Re: City of Dietrich Environmental Information Document Addendum No. 2

Please find this letter in response to your email dated July 13, 2011 requesting additional information regarding the *City of Dietrich, Water System Improvements Environmental Information Document (EID)*. This letter constitutes a letter addendum No. 2 to the original EID approved by DEQ on April 13, 2012. Responses have been prepared for each bullet in the July 13th email (attached for reference).

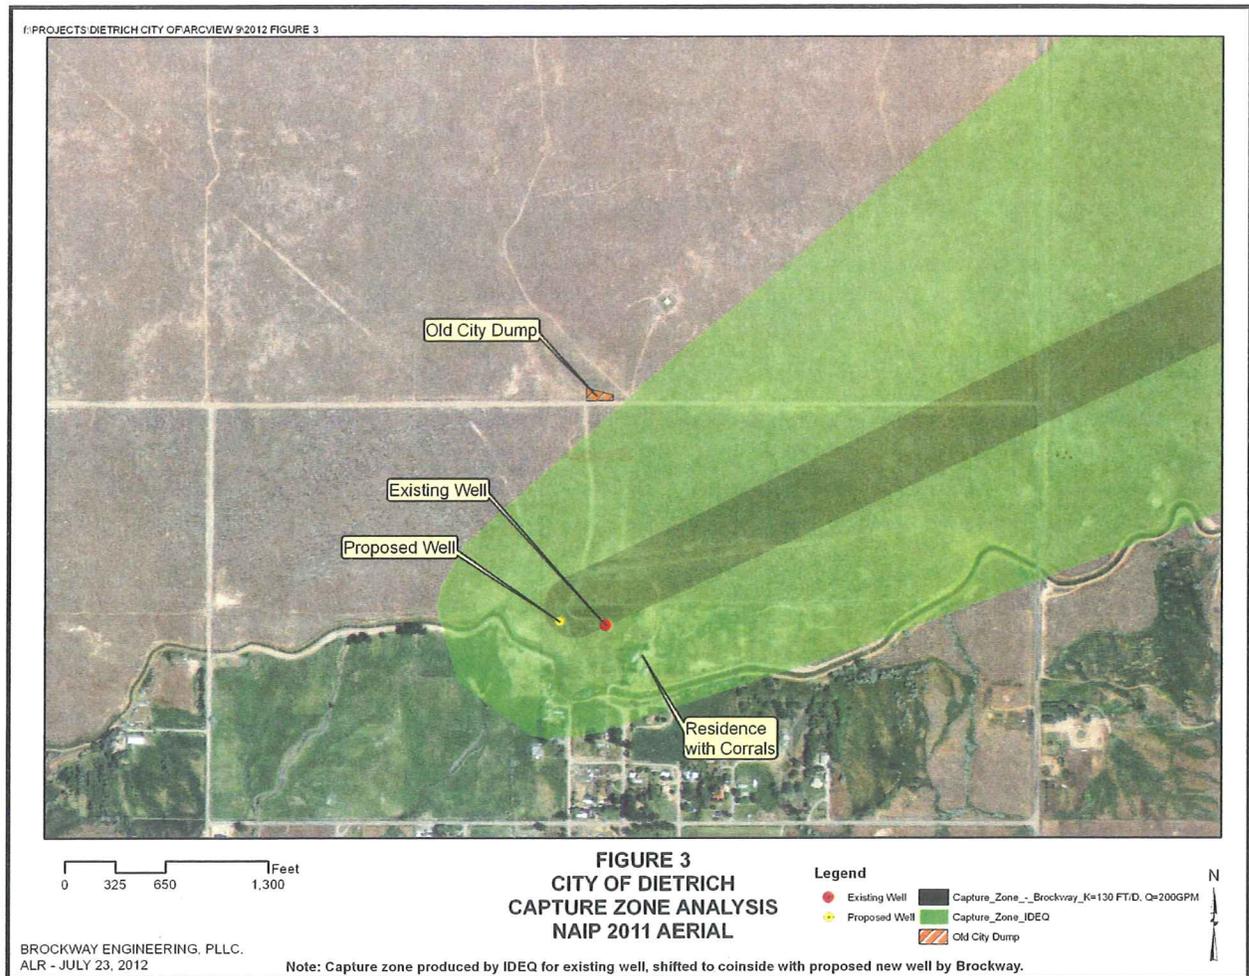
5th Bullet—The hydraulic modeling and text narrative presented in Bullet #5 and #6 of the letter dated July 9, 2012 and this letter was completed under the supervision of Chuck Brockway, a professional geologist and engineer. The capture zone analysis was completed for a continuous discharge rate from the new well of 200 gpm, or 38,503 ft³/day. The 20-year peak day demand is estimated to be 180 gpm; consequently, 200 gpm is a conservative assumption. Aquifer parameters were the same as described previously. The resulting capture zone is slightly wider due to the increased discharge rate, and is plotted on the following revised Figure 3.
